STAFF RECOMMENDATION
105 South 12th Street
December 18, 2019

Application: New Construction—Addition; Partial Demolition
District: Lockeland Springs-East End Neighborhood Conservation Zoning Overlay
Council District: 06
Base Zoning: R6
Map and Parcel Number: 08309017300
Applicant: Kaitlyn Smous, Nine12 Architects
Project Lead: Melissa Baldock, melissa.baldock@nashville.gov

<p>Description of Project: The applicant proposes to construct dormers and alter the roof form of the historic house.</p> <p>Recommendation Summary: Staff recommends approval of the right side dormer, with the condition that staff approve the window and roof shingle selections, finding that it meets Section II.B. of the design guidelines.</p> <p>Staff recommends disapproval of the alterations to the roof on the left side of the house, finding that this proposed partial demolition and alterations to the roof form do not meet Sections II.B. and III.B. of the design guidelines for the Lockeland Springs-East End Neighborhood Conservation Zoning Overlay.</p>	<p>Attachments A: Site Plan B: Elevations</p>
---	--

Figure 5 shows the location of the proposed side dormer.

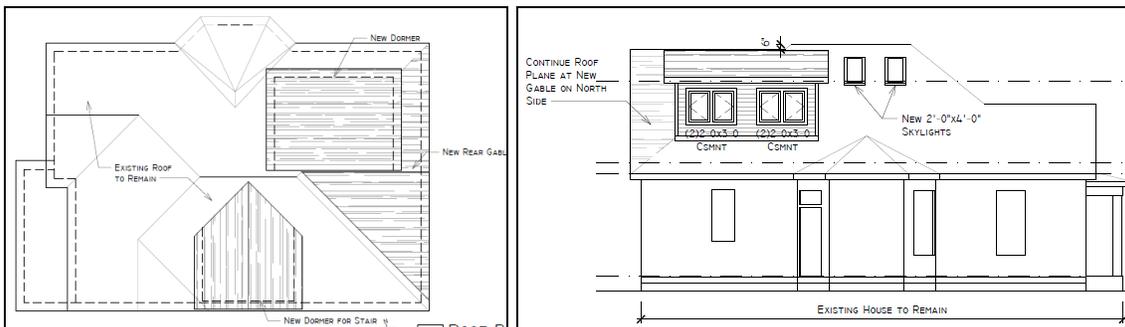
On the right side of the hip, the applicant is proposing a side dormer (Figure 5). The design guidelines state that “*The ridge of a side dormer should be at least 2’ below the ridge of the existing building; the cheeks should be inset at least 2’ from the wall below or adjacent valley; and the front wall of the gable should setback a minimum of 2’ from the wall below.*” The

The proposed dormer does not meet these requirements, as it is just six inches (6”) off of the ridge, is not set back two feet (2’) from the wall below, and is just a few inches from a valley. Staff finds in this instance that an exception could be made for this side dormer because its size and location are necessary in order to add a staircase to the second level. The dormer is larger than what the Commission would typically approve in that it is not adequately set off from the ridge, valley, and wall below. However, because there is no way to add on to the rear, as there is with almost every other house in this and other historic and conservation overlays, staff finds that that flexibility with the design guidelines is appropriate in this instance. Overall, the dormer’s scale is not overly large and is designed to be the minimal size it can be while still serving as a way to obtain a staircase to the second level.

Recommendation Summary: Staff recommends approval of the right side dormer, with the condition that staff approve the window and roof shingle selections, finding that it meets Section II.B. of the design guidelines.

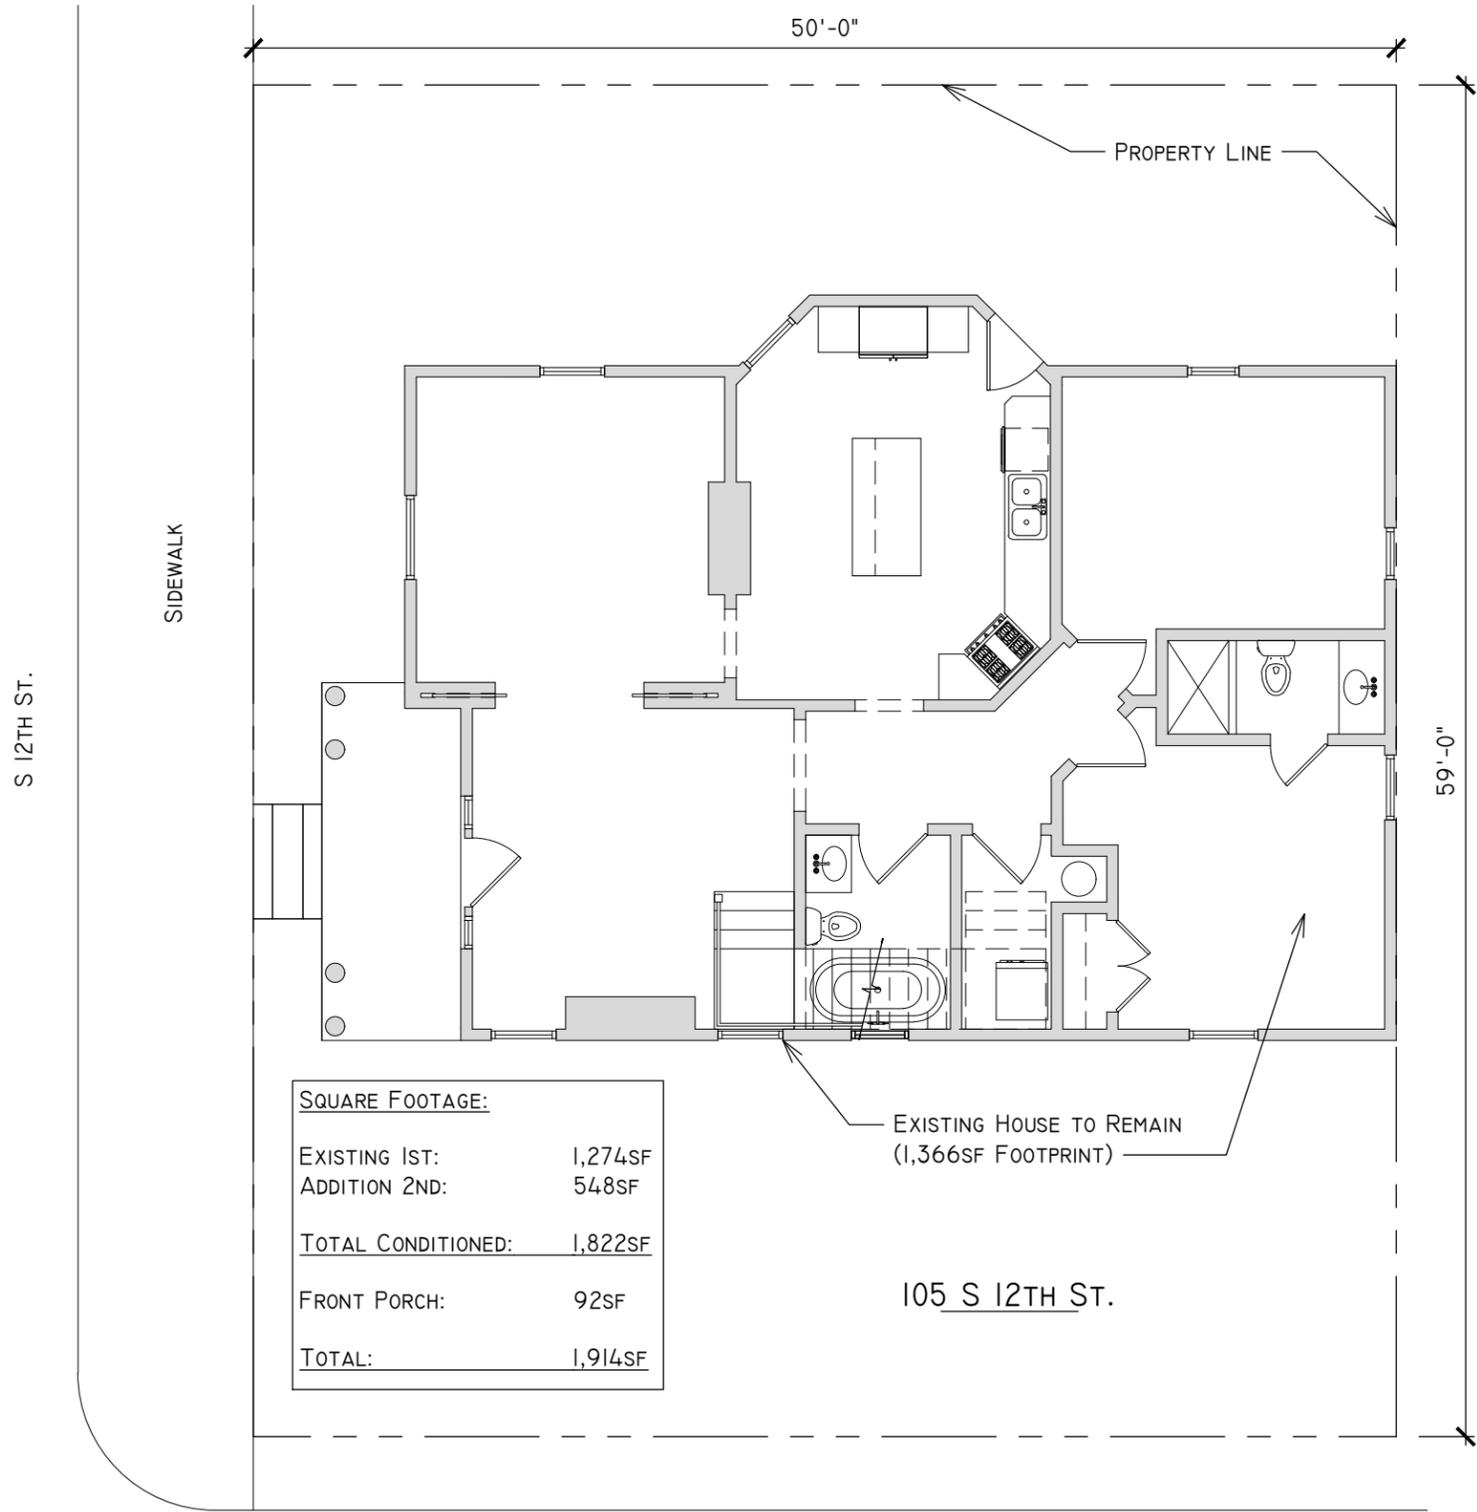
Proposed	Color/Texture/ Make/Manufacturer	Approved Previously or Typical of Neighborhood	Requires Additional Review
Cladding	cement fiberboard lap siding, match reveal of existing	Smooth	Yes	No
Roofing	Architectural Shingles	Match existing	Yes	No
Trim	Wood or Cement Fiberboard to match existing	Smooth faced	Yes	No
Windows	Not indicated	Not indicated	Unknown	Yes

With the condition that staff approve the window selection, staff find that the known materials meet Sections II.B.4. and II.B.10. of the design guidelines.

1 SITE PLAN/1ST FLOOR PLAN

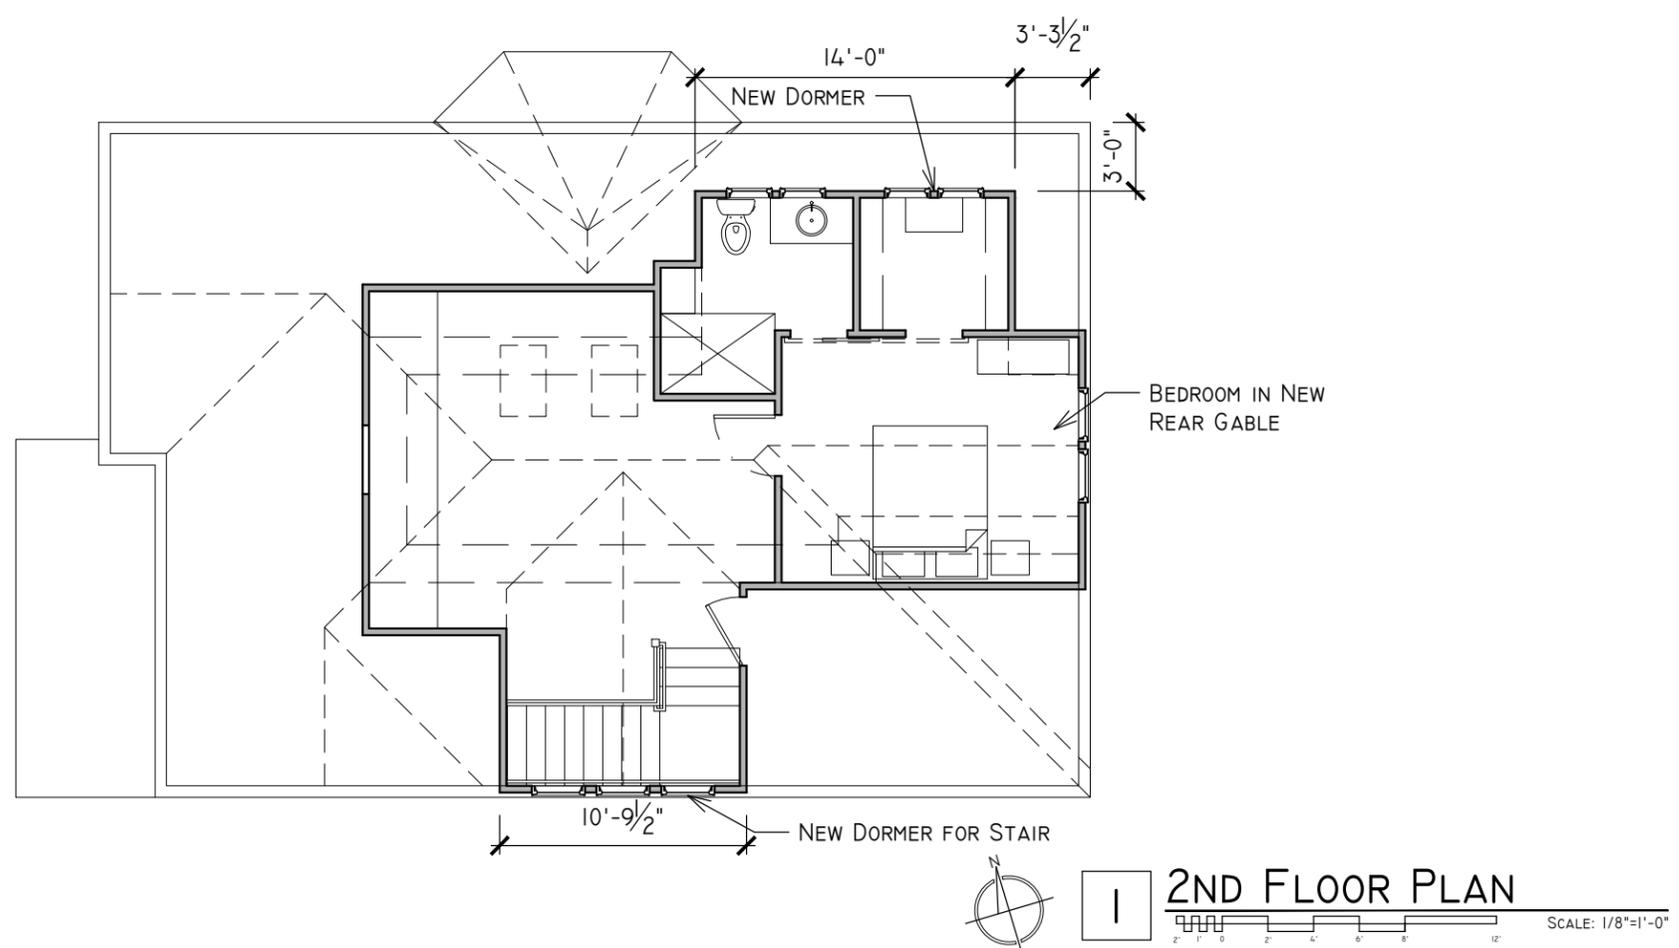
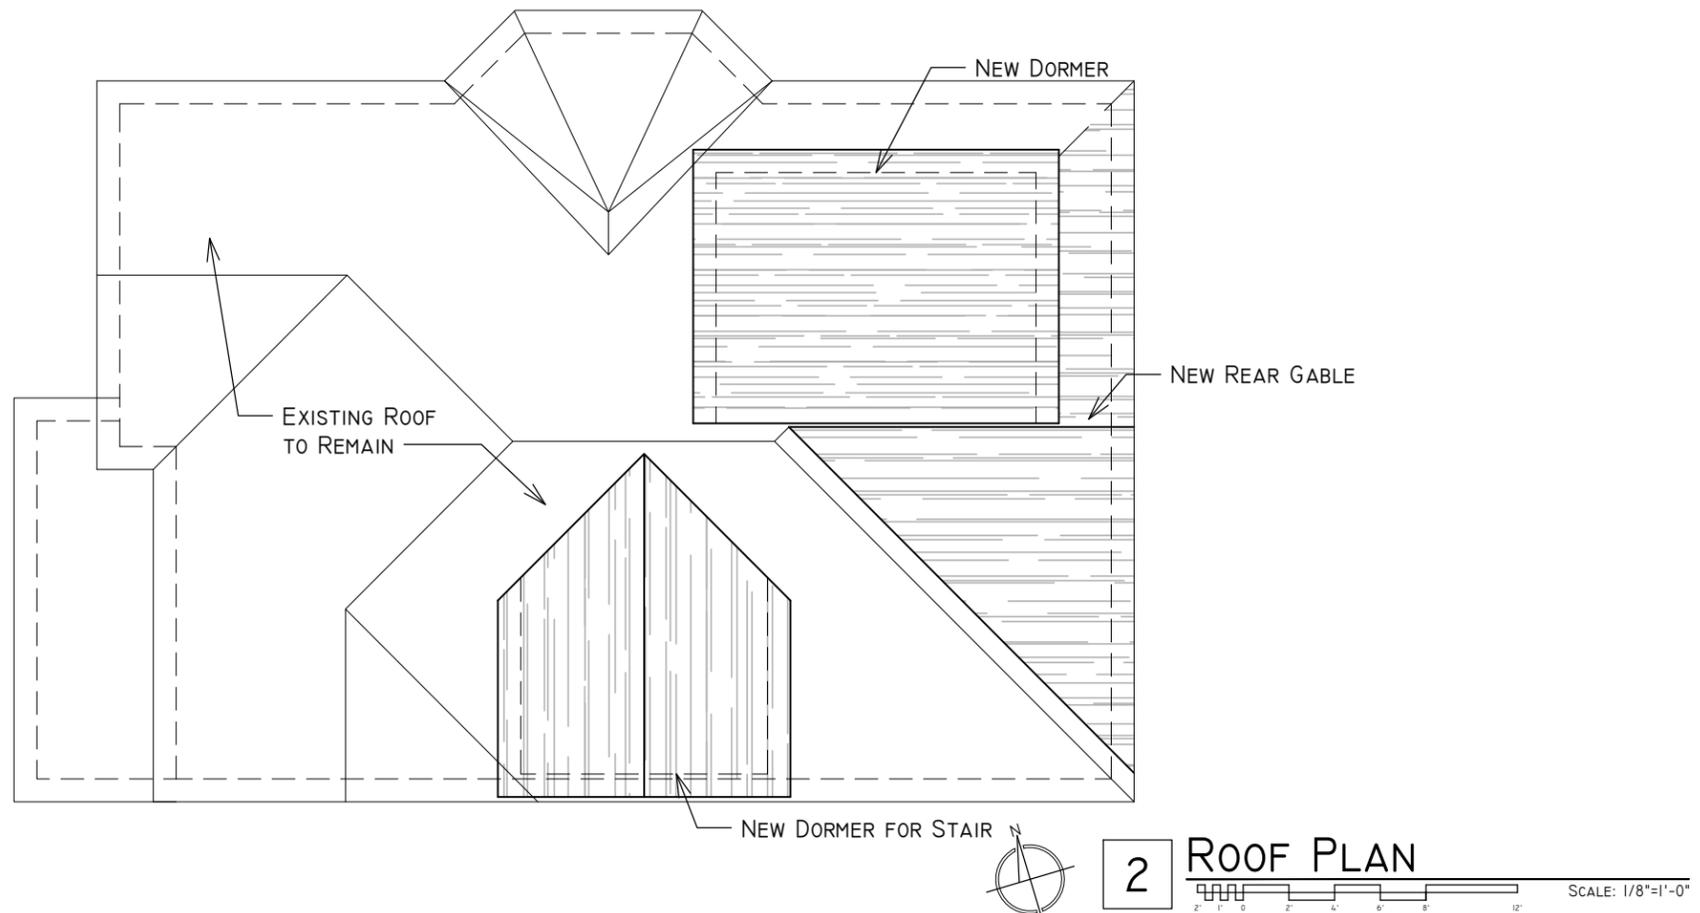
On the rear, the applicant plans to add a gabled extension. On the right/alley side, the gable portion of the roof is offset from the roof six inches (6”), allowing the house’s original roof form to still be identified. However, on the left side, this gabled addition at the rear will not inset and will eradicate the rear hip roof form. (Figures 6, 7, 8, 9, 10).

Figures 6 (roof plan) and 7 (left side elevation) show how the back hip will be eradicated on the left side.

While staff understands the challenges of this site and its lack of a rear yard for a rear addition, staff finds that completely removing the back hip portion of the roof is not appropriate. It alters the primary roof form, which is a significant architectural feature, in a manner that does not allow the existing roof form to be discerned. The proposed changes to the roof are also not reversible; if the addition were to be removed in the future, nothing would remain of the hip on this back left side of the house. Staff finds that the alterations to the roof form on the left side are not appropriate partial demolition.

Staff recommends disapproval of the alterations to the roof on the left side of the house, finding that this proposed partial demolition and alterations to the roof form do not meet Sections II.B. and III.B. of the design guidelines for the Lockeland Springs-East End Neighborhood Conservation Zoning Overlay.
